Sent: 5/09/2022 11:01:00 AM
Subject: Submission to DA 2021/2567 60 Federal Parade, Brookvale St Augustine's College Brookvale
Attachments: 11771 Submission.pdf;

RE: DA 2021/2567

Property: 60 Federal Parade, Brookvale St Augustine's College Brookvale

St Augustine's owned properties.

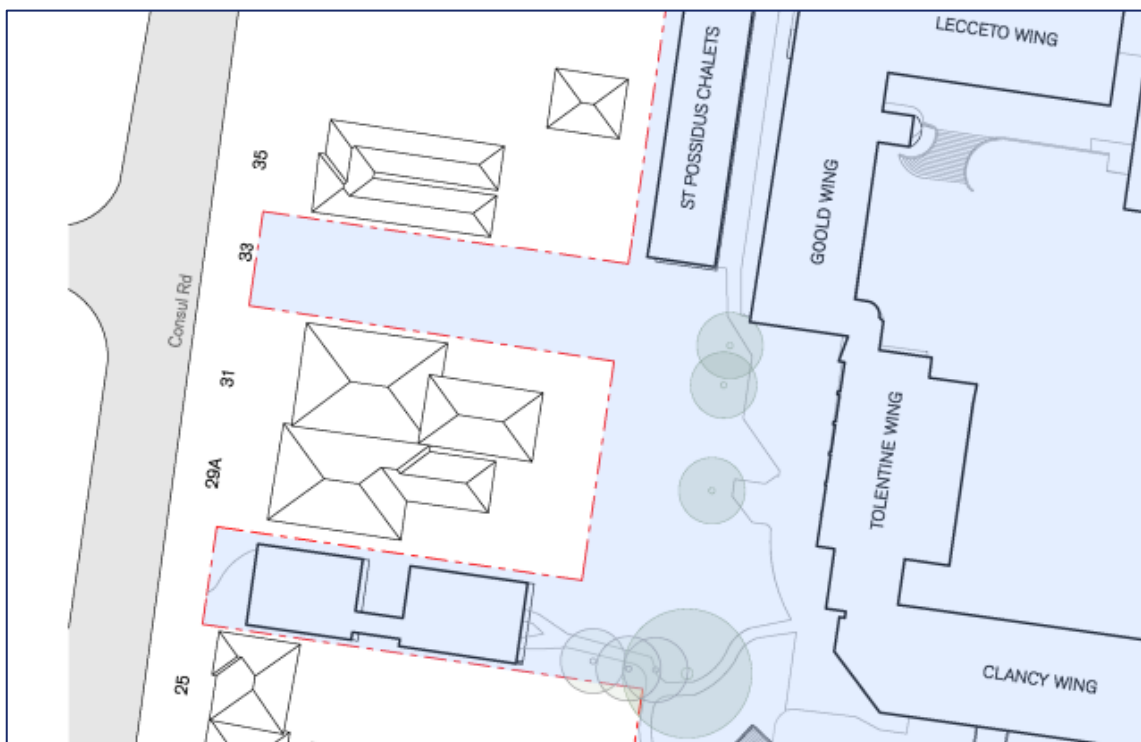
It is clear that St Augustine's does not intend to limit the development to the sites identified in this application. A review of land ownership within the vicinity of the site has revealed the college now owns at least two additional properties as identified in red below. In light of these purchases and a failure to identify a potential use for these properties within this application, it is premature to consider an increase in student numbers beyond the current enrolment which is indicated to be in the order of 1400 -1500 students.

The SEE describes that despite the increase in student numbers there is no proposal within this DA, for any additional floor area increase on the site. This position is inconsistent with the recent improvements and site acquisitions within the locality. A review of the landownership within the vicinity indicates in addition the properties approved for use identified within the SEE, the parcels in green outline are also owned by St Augustine's. It is also understood within the neighbourhood that No 50 Alfred Street (green dash outline) has been acquired with settlement due this week. No 50 Alfred is located immediately to the north of the Federal Parade proposed carpark.

Aerial Photograph 12 March 2019

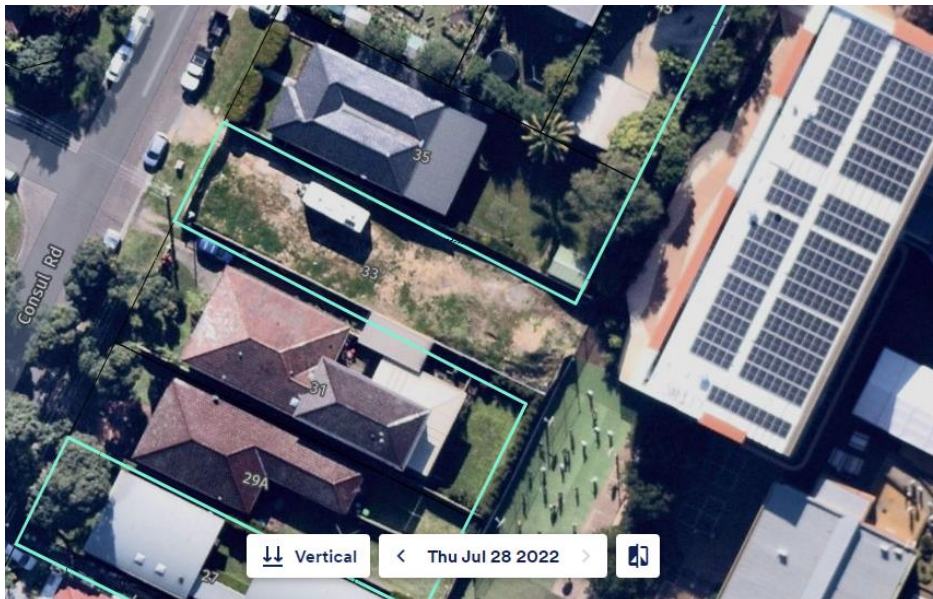
During 2019, No 33 Consul Road was used for construction access, notably for building works that were not identified within DA 2018/1804 as shown in the aerial photograph below dated 12 March 2019.

These construction works resulted in filling at the rear of No. 33 including a ramp over the Greendale Creek overland flow path and Council easement (within the yellow circle). Upon the completion of works the overland flow path was partially cleared but the filling has remained within the fence line of No 33. Our client is unaware of any approval for these works and does not recall any notification being given. The land is yet to be stabilised from a soil and water management point of view and in times of rain turbid water and sediment is washed off these unstabilised works, onto our clients property.

Our client would interested to see a copy of the Council approved plans for these filling works and supporting stormwater and flooding report supporting the modification to Council overland flow path prior to the commencement of those works. If Council consent was not obtained one as part of those works, it should be required as part of this current DA, as this approval may be default approve works for which consent is required.

Extract of Plans for DA2020/1514 (Withdrawn)

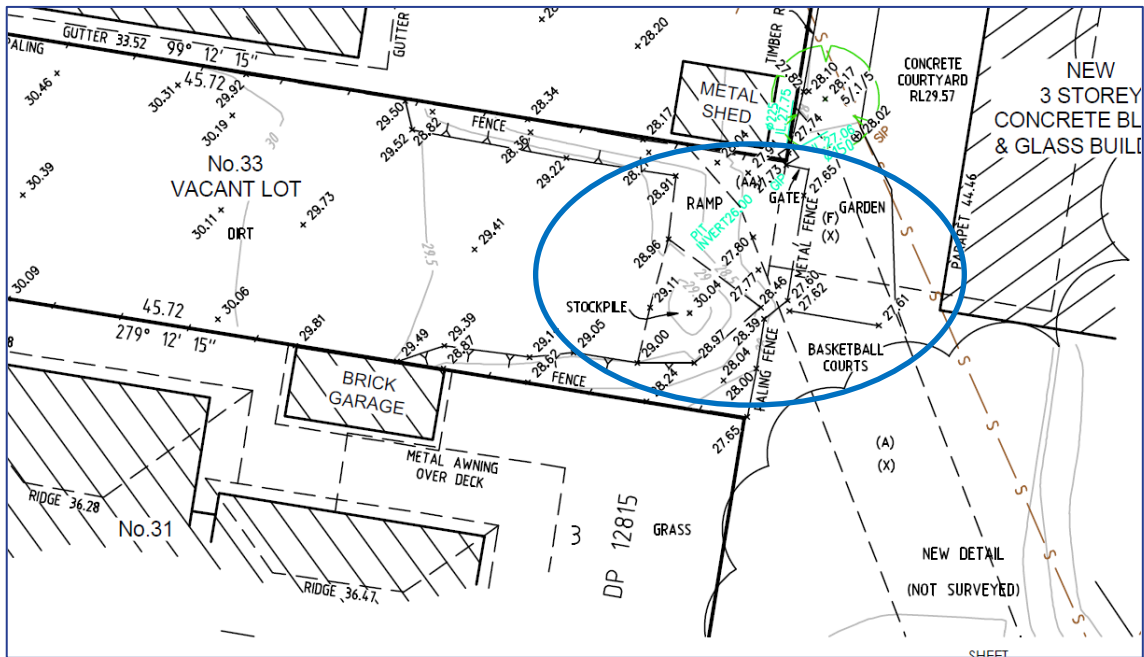
DA 2020/1514 for "Alterations and additions to an existing educational establishment to accommodate an increase of student numbers" was submitted in November 2020 and withdrawn in March 2021. The SEE that supported the withdrawn DA indicated the school was seeking approval for an increase in school numbers from 1200 to 1500 students with a request to provide parking facilities on No 33 Consul for 15 additional spaces. We understand that this application was withdrawn as a result of Council's initial assessment.

Extract of survey undertaken by LTS Lockley (Rev I dated 18/8/2020)

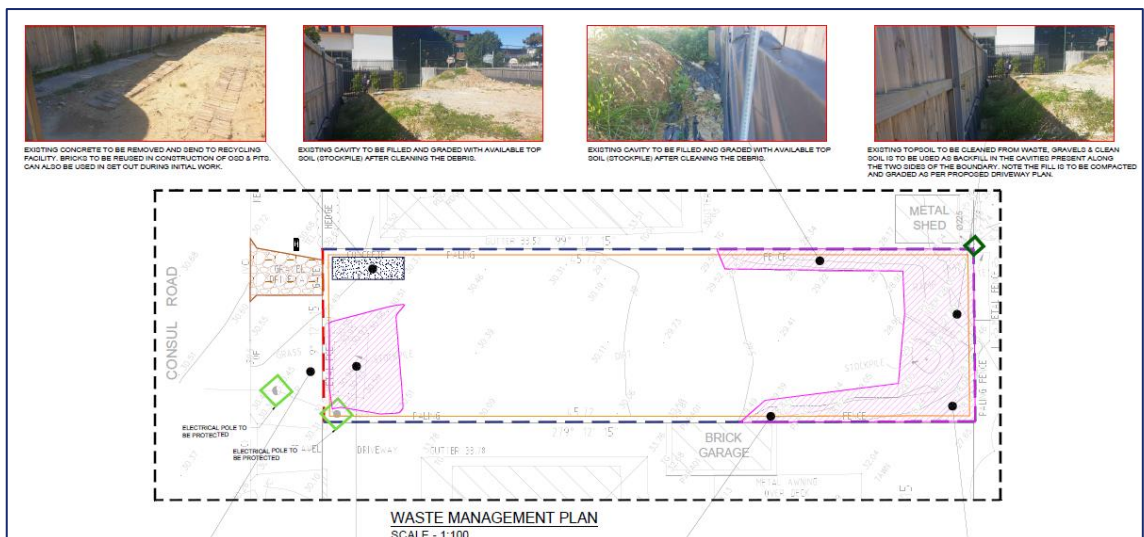
We note that in the withdrawn submission is a survey undertaken by LTS Lockley (Rev I dated 18/8/2020) and submitted as part of DA2020/1514. The survey shows the unapproved filling works and stockpile as an "existing" landform, and not as unapproved filling works. It also shows the batters from these works extending across the Council easement modifying the existing overland flow path. Refer to plan extract below.
